## Panel Mount Pro 120 Remote Control - Mariner 175 SKI

Some Pro 120 remote controls P/N 88150A17 (Figure 1) may have been assembled with an incorrect housing. An incorrect housing may prevent shifting from forward gear into neutral. Remote controls listed that were shipped from Quicksilver stock and with Mariner 175 SKI outboards require inspection.

Figure 2. Back of Remote Control

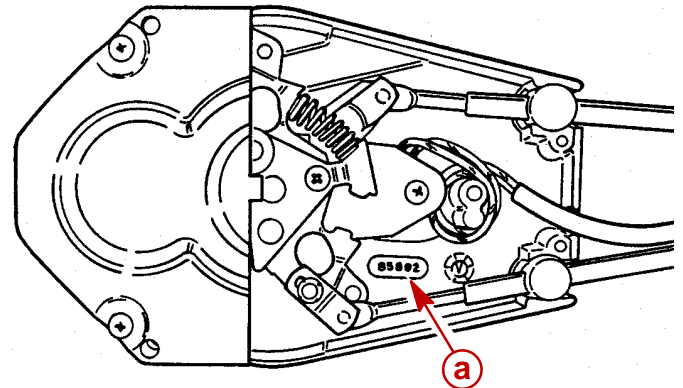
Remote control with casting number 85892 (Figure 2) requires complete remote control replacement.

Replace with P/N 88150A17 remote control that has 19826, 814841 or 815729 housing. Remote controls with date code 1/26/90 and later have the correct housing installed.
